KeContact P30

Software release notes Package 1.4

Author: brc Version date: 24.03.2017

2.2.1. Unused logs have been removed

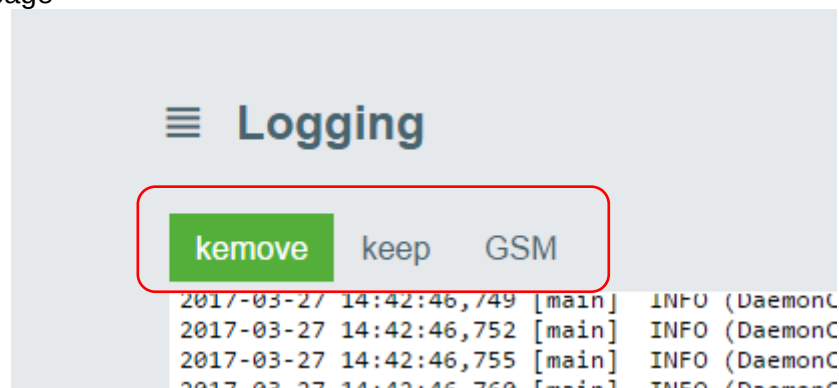
Unused tabs like "kremove-wrapper" and "keep-wrapper" have been removed from the logging web page.

3.3.2. Save charging sessions

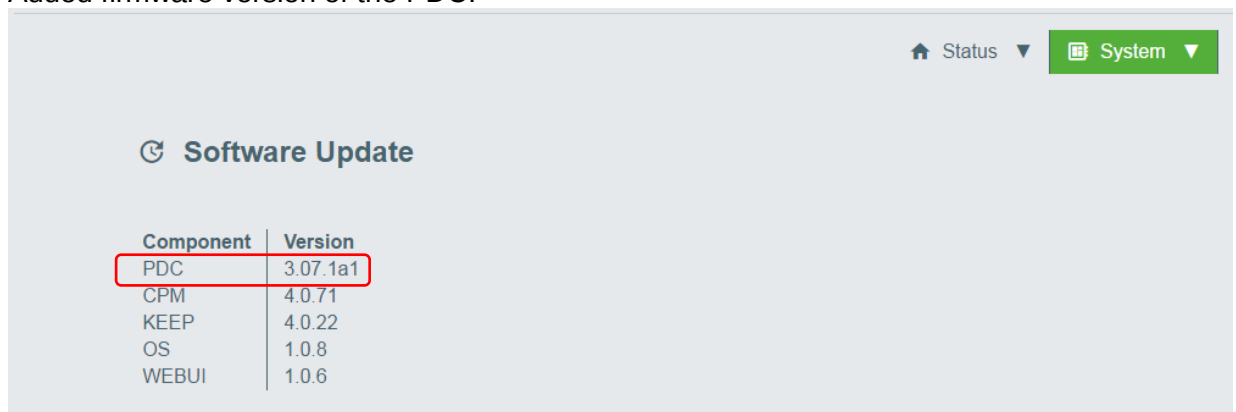
When the P30 is powered off during the charge, the date of the charging sessions are saved.

3.3.5. WebUI – Logging

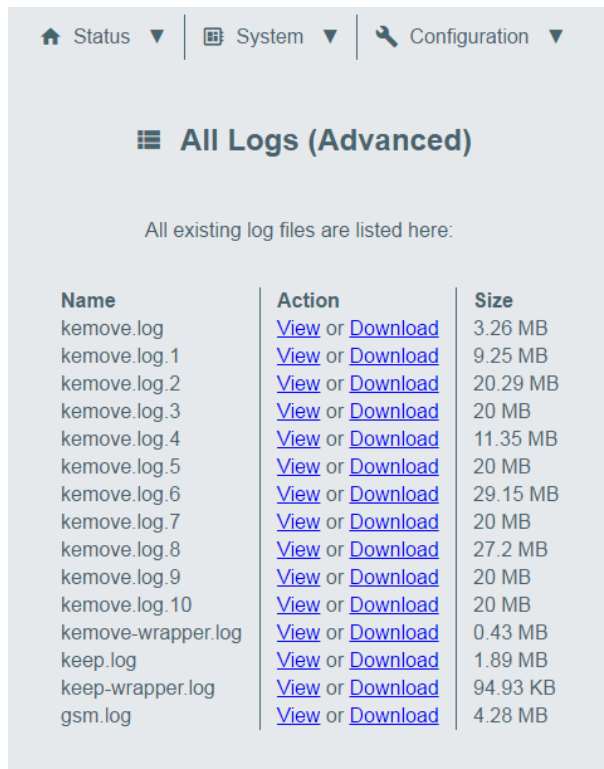
Added "All Logs" button to "Logging" tab, allows individually viewing and downloading every single log file.

Here is shown a screen shot of what the user can see if clicking on “ All Logs”.

3.3.7. WebUI – component version

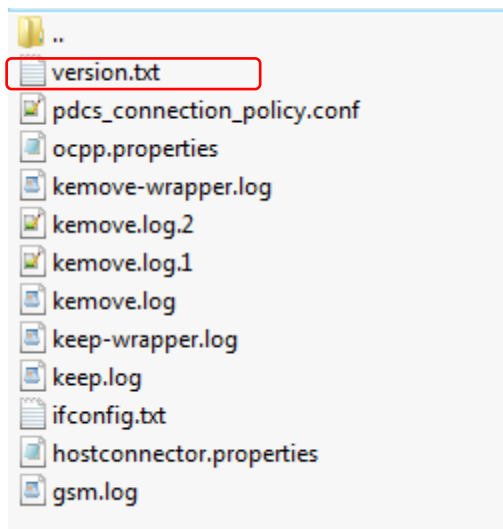
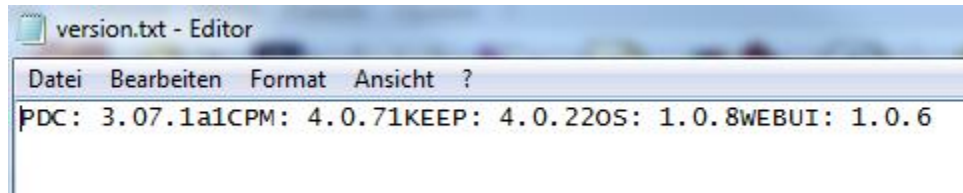
Added the text file “version.txt” in zip file accessible by clicking on "Download Latest".

In this file are enclosed the information related to the versions of the software component.
